MONTGOMERY COUNTY HISTORIC PRESERVATION COMMISSION
STAFF REPORT

Address:	15 W. Lenox Street, Chevy Chase	Meeting Date:	3/23/2022
Resource:	Contributing Resource Chevy Chase Village Historic District	Report Date:	3/16/2022
Applicant:	15 W. Lenox Trust Henry Chuang, Architect	Public Notice:	3/9/2022
Review:	Historic Area Work Permit	Tax Credit:	n/a
Case Number:	984980	Staff:	Dan Bruechert
Proposal:	Partial Demolition, Rear Addition, Side Addition, Grading, Tree Removal, and Hardscape Alteration

Staff recommends that the HPC approve the HAWP with two (2) conditions:

Figure 10: Detail of proposed porch.

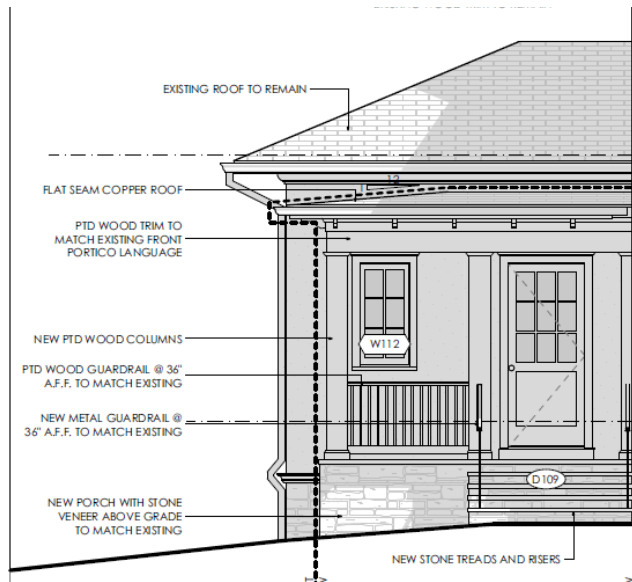
The front porch measures approximately 5' × 13' (five feet deep by thirteen feet wide) and will have a stone veneer foundation to match the house; wood decking, treads, and columns; and a painted metal railing to match the existing. The low pitched (1:12) hipped roof will have a flat seam copper roof. Staff finds the proposed porch is appropriately detailed for the house and the materials are all traditional building materials. Staff finds the proposed porch satisfies the requirements in the *Design Guidelines* and satisfies the requirements of 24A-8(b)(2).

TREE INVENTORY AND DEMO PLAN

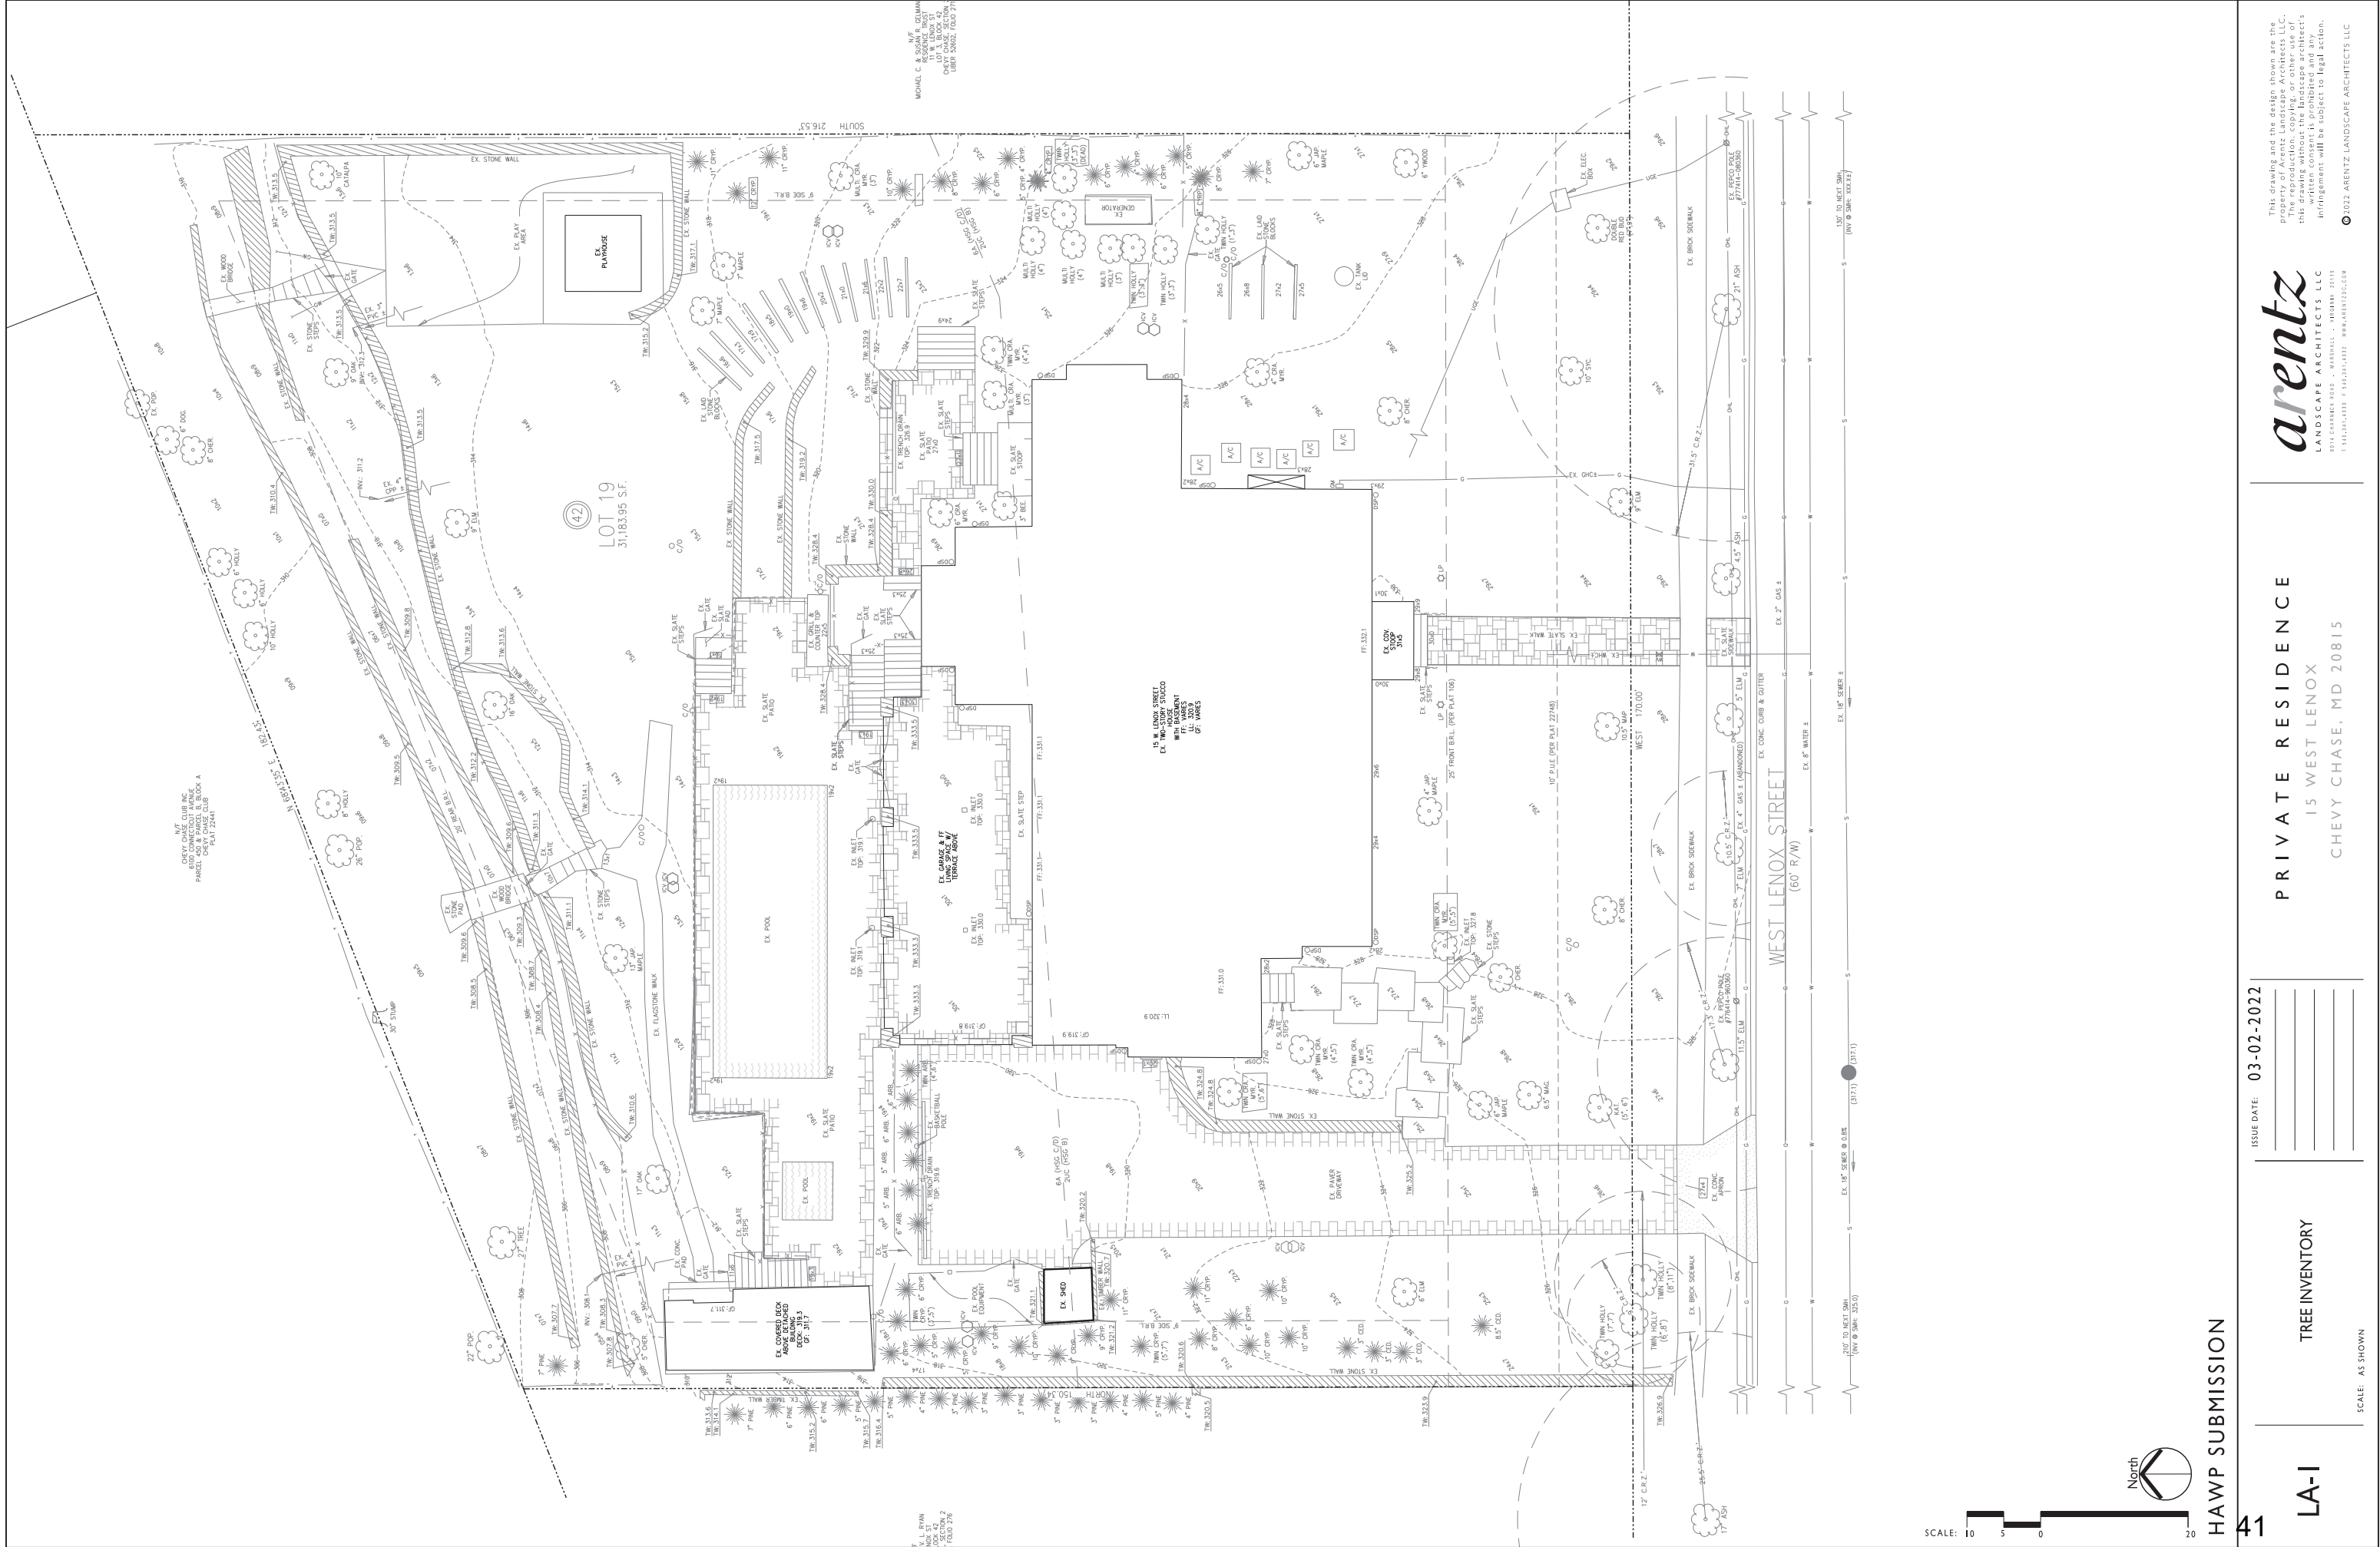
The last landscape change is the removal and planting of several trees on site. In addition to the tree mentioned above, there are also a 9" (nine-inch) elm, a 13" (thirteen-inch) maple tree, two 8" (eight-inch) cherry trees in the front yard, and a 9" (nine-inch) elm in the front yard all proposed for removal that are all subject to HPC review and approval. The landscape plan also proposes planting an additional 16 (sixteen) trees throughout the property. No species were identified for the replacement trees. Staff finds that planting new trees at nearly a 2:1 ratio is acceptable mitigation based on the trees on site. However, Staff recommends the HPC include a condition for approval that a final landscape plan needs to be submitted with the permit drawings that identifies the proposed species and size to be planted on site, so that when the project is complete, Staff is able to verify the planting occurred as proposed. Staff recommends the HPC approve the landscape and hardscape alterations with the conditions identified.

3. The approval of this court does not extend to the proposed entry court and a new front walk cannot exceed the dimensions of the existing walk.
4. A final landscape plan that identifies the location, species and size of the sixteen trees to be planted on site needs to be submitted with the final permit drawings;

ILLUSTRATIVE SITE PLAN

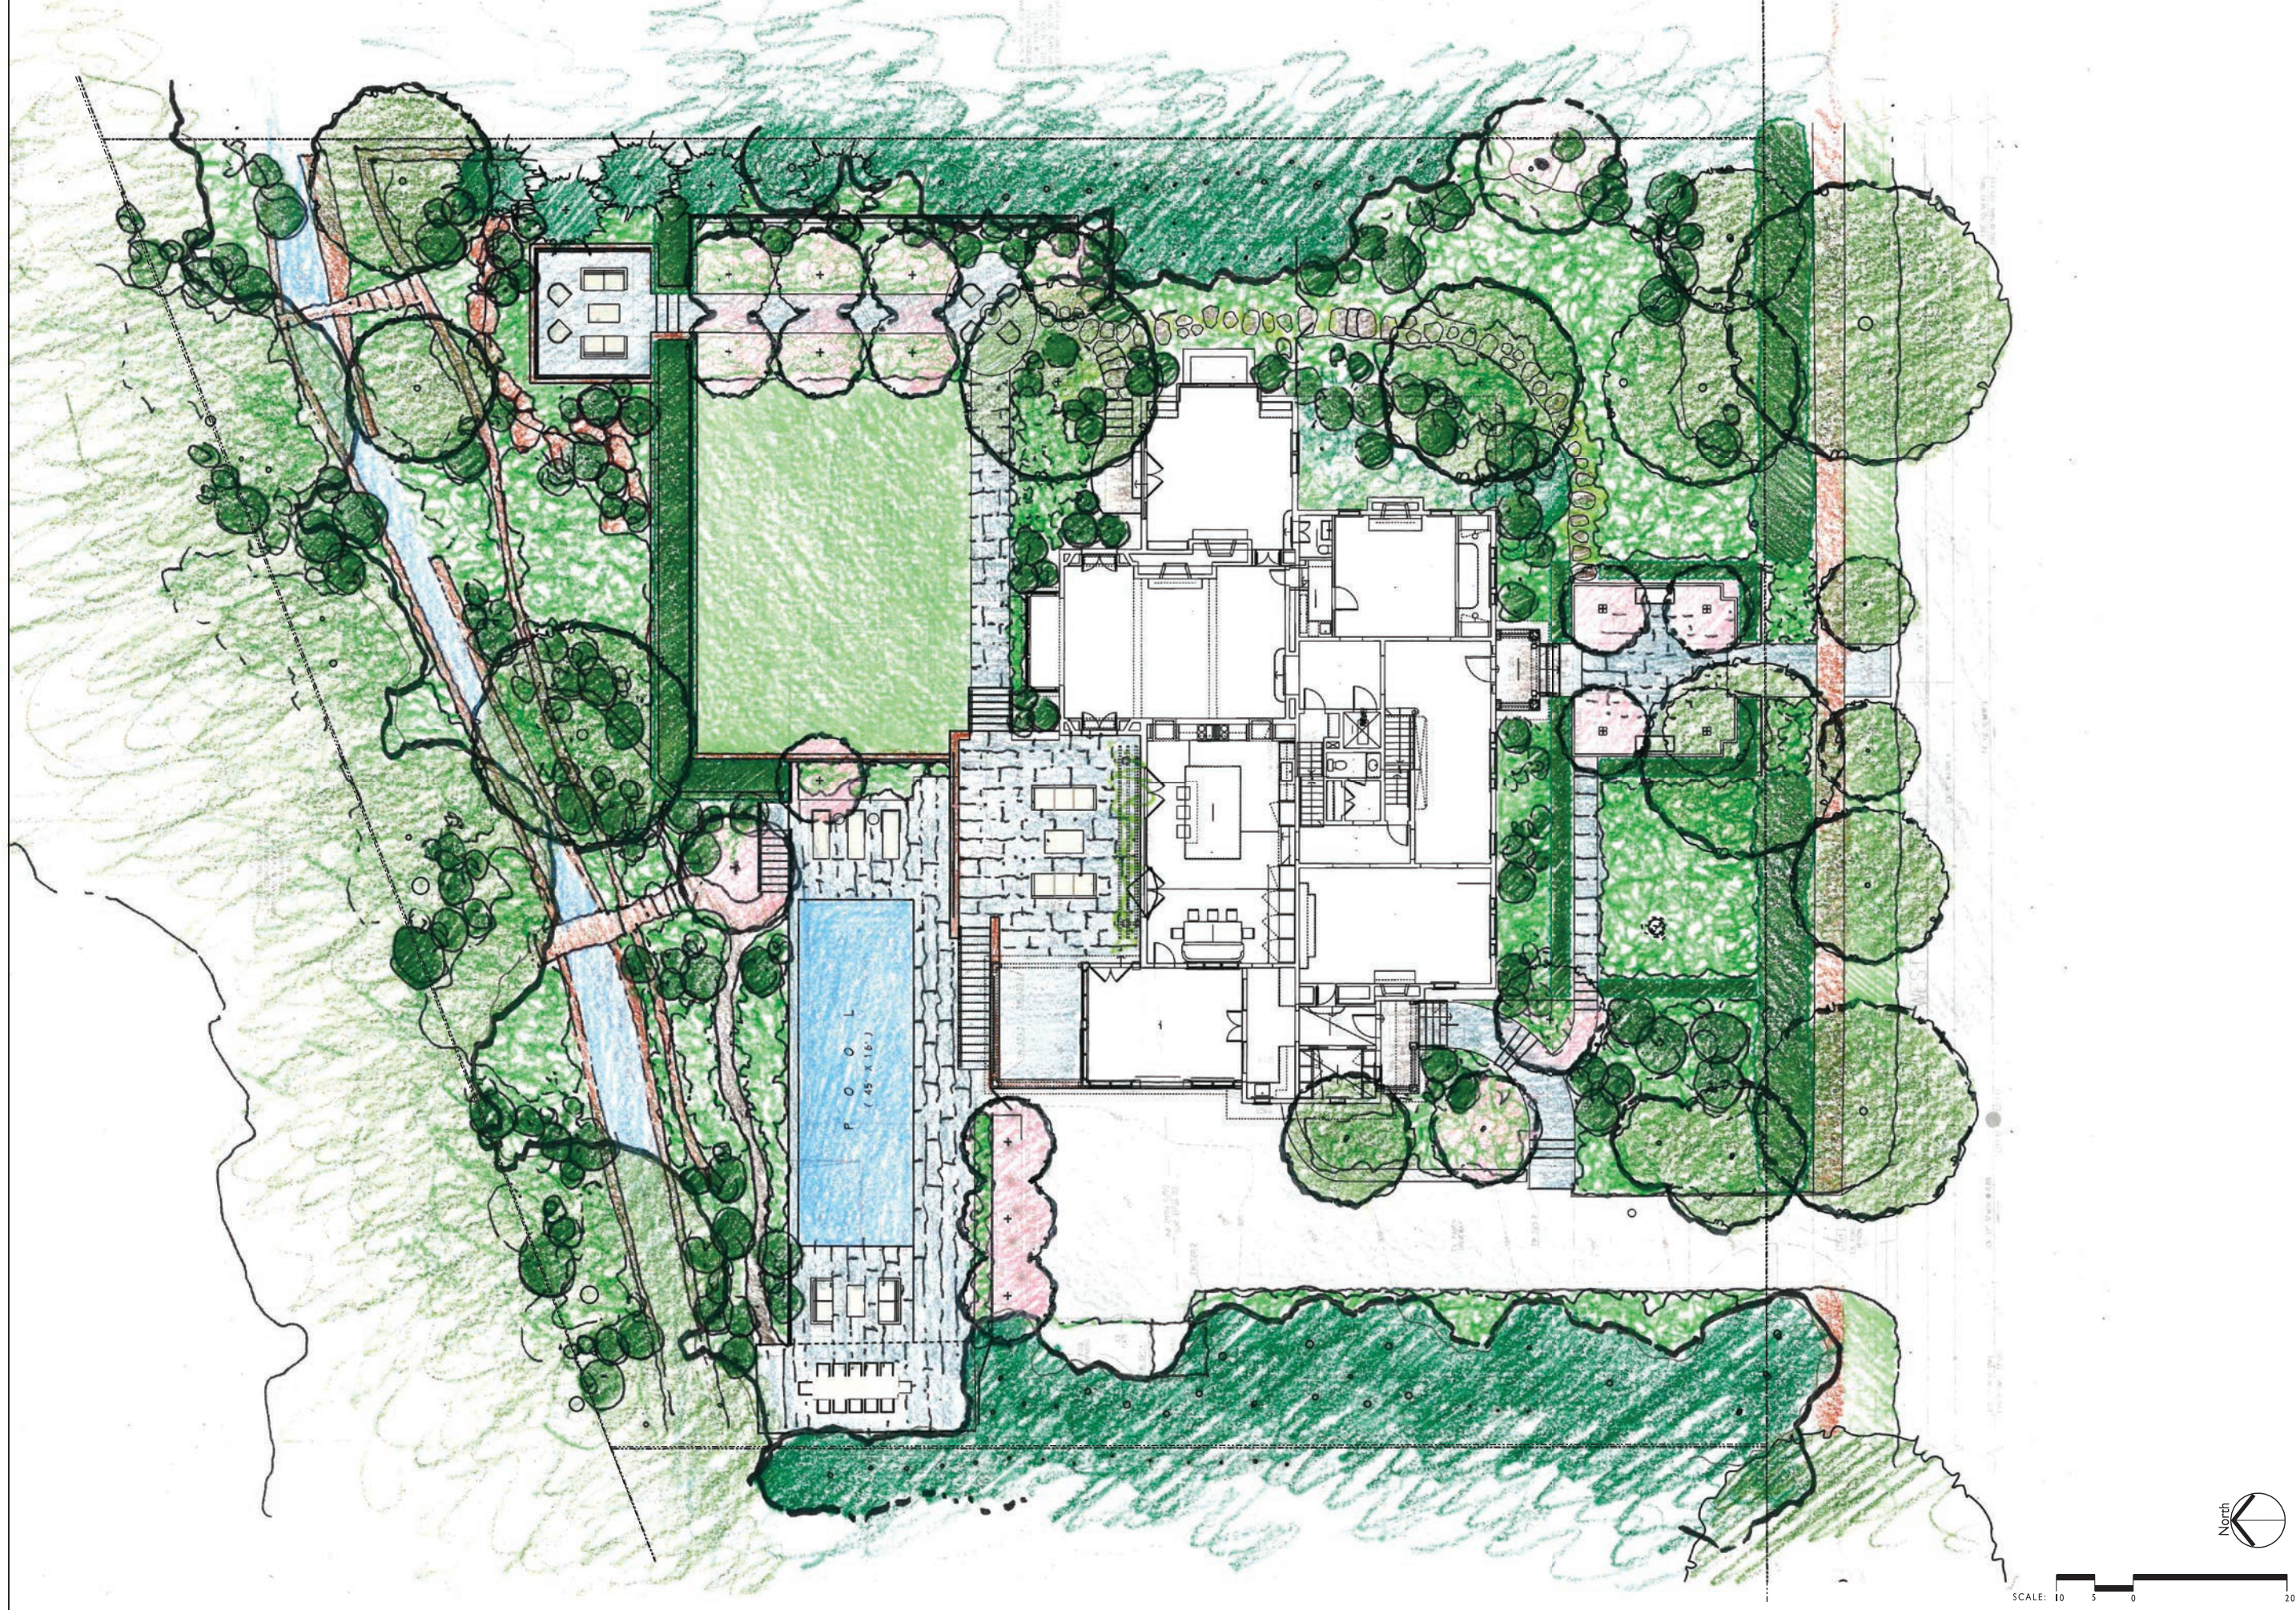
At the front of the house, the applicant proposes to install a new stone walkway to the front door, that includes an 'entry court.' The entry court will be surrounded by hedging and will have benches that measures approximately 26' 6" x 27' (twenty-six feet, six inches deep, by twenty-seven feet wide). Additionally, the applicant proposes to install a stone walkway from the existing driveway to the west addition and new porch, and then extends to the entry court.

Staff finds the proposed stone walk is in an appropriate location and will produce a varied surface that is desirable in the Chevy Chase Village Historic District. However, Staff finds that the proposed entry court introduces too much paving at the front of the house and detracts from the district's park-like setting. The size of the entry court is larger than a standard two-car garage and even though the proposal will be obscured by hedges, needs to be considered in the absence of vegetation. Staff recommends the HPC include a condition for approval that a new front walk cannot exceed the dimensions of the existing front walk. There is nothing to prevent the applicants from creating an entry court utilizing the identified hedges and benches, however, any expansion beyond the existing paving needs to be landscaped (i.e. grass or other ground covers) rather than hardscaped.
